STAFF RECOMMENDATION
114 Second Avenue South
April 17, 2019

Application: Rehabilitation: Lighting, Facades, Windows, Decorative Elements and Signage

District: Broadway Historic Preservation Zoning Overlay

Figures 1 and 2: The projector is located in the ceiling of the recessed entry. The second image shows the projection on the sidewalk.

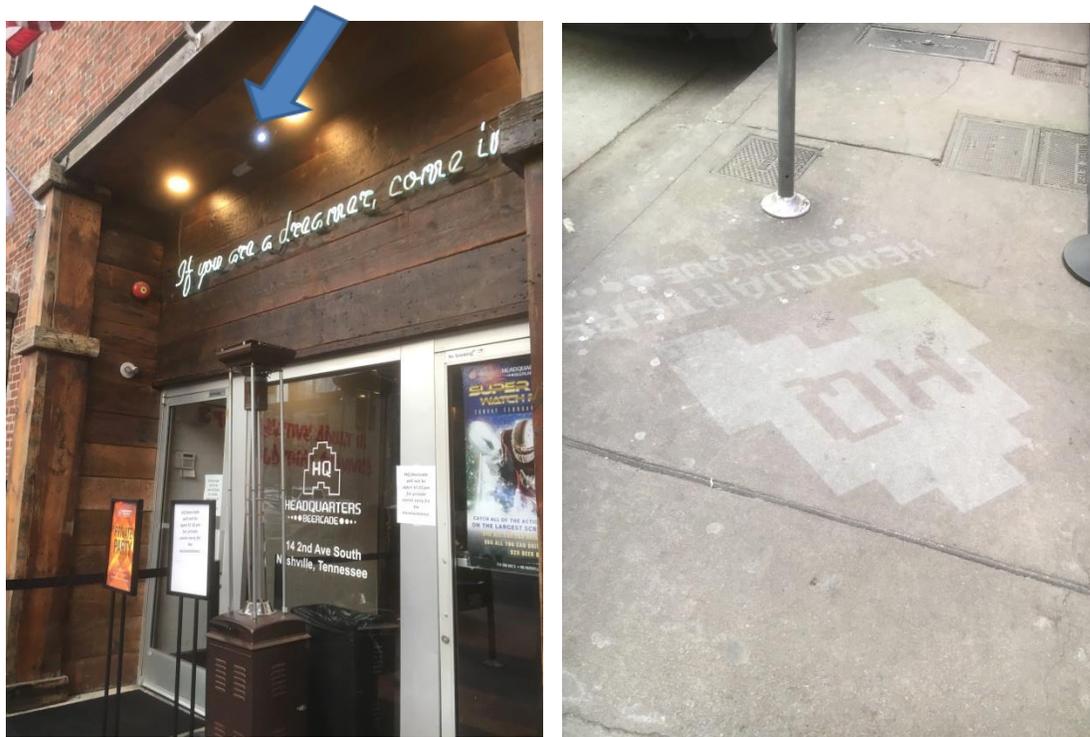
Location: Although the light fixture is readily visible from a public right-of-way, it is partially concealed by being located within the recess of the entry and is not obtrusive. The device itself is very small and there is only one on the building. The applicant did not provide any information regarding their request; however, a common Gobo size is approximately 10" x 5" x 10". It meets Section II.T.1.

Installation: Installation of the fixture did not require removal or alteration of historic features and therefore meets Section T.

Lighting: The design guidelines require that illumination be directed towards the building rather than outward, and in this case, the illumination component of the projection is directed away from the building and on to the sidewalk. Because this is a Gobo light, the illumination itself cannot be seen, except for the projection on the sidewalk. The intent of this design guideline assumes that building illumination is to highlight building features but in this case, the projection has the purpose of serving as signage. It does not project out horizontally or up into the sky but is directed to the ground. It is not directed onto the historic building and so does not change the character or design of the building. Staff finds that the downward, sidewalk projection is appropriate since the illumination cannot be seen except for the projection on the sidewalk, and the illumination does not change the historic character of the building. The project meets Section II. T.1

Materials: The material for the device is metal which is appropriate for lighting. The project meets Section II. T.1 of the design guidelines.

Recommendation: Staff recommends approval of the one Gobo light in its current location and with its current direction towards the sidewalk and the side-wall light, finding the project meets Section II.T1 for lighting.

Figure 7: Current conditions showing trim previously disapproved still in place and new signage in the same location as that was previously disapproved.

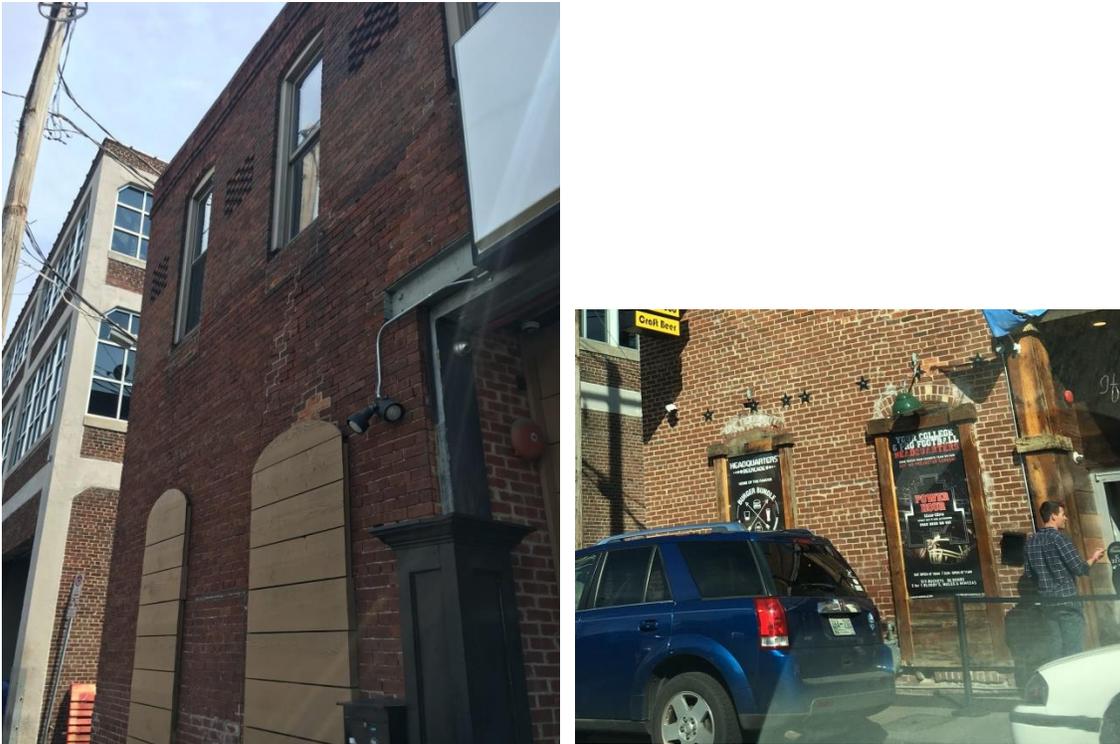
Signage was installed over the boarded-up windows without a permit in 2017. (Notice of violation was sent on December 14, 2017.) In July 2018, the applicant requested to retain the signage, was denied by the Commission, and removed the signage but has since installed new signage in the same location. See Figure 7.

Location: The signage was installed over boarded up windows without a permit. The trim was previously installed without a permit and was disapproved by the Commission in July 2018 as was considered part of the signage. The windows were boarded up before the applicant acquired the building. In the provisions for wall signs, the design guidelines states, "a wall sign cannot cover windows or architectural details." In this case, the signs cover the window openings and are in an inappropriate in the current location, whether or not the windows are boarded up. The materials of the signage were not provided but it appears to be painted signage. The design guidelines for signage does not allow for painted signage on the first level.

Consideration: If the applicant wishes to have signage in that location, it could be achieved by installing windows that meet the design guidelines, removing the window coverings, and installing signage on the inside of the windows. Interior signage seen through windows is not reviewed by MHZC.

The project does not meet Section IV. Signage.

Staff recommends disapproval of the signage, finding that it does not meet Section IV. for signage and of the window trim, finding that it does not meet Sections II. H and II. K for rehabilitation of windows or decorative elements and the goose neck lighting finding that it does not meet section II.T for lighting. Staff further recommends that the trim and signage are removed within 60 days of the date of the Commission's decision.
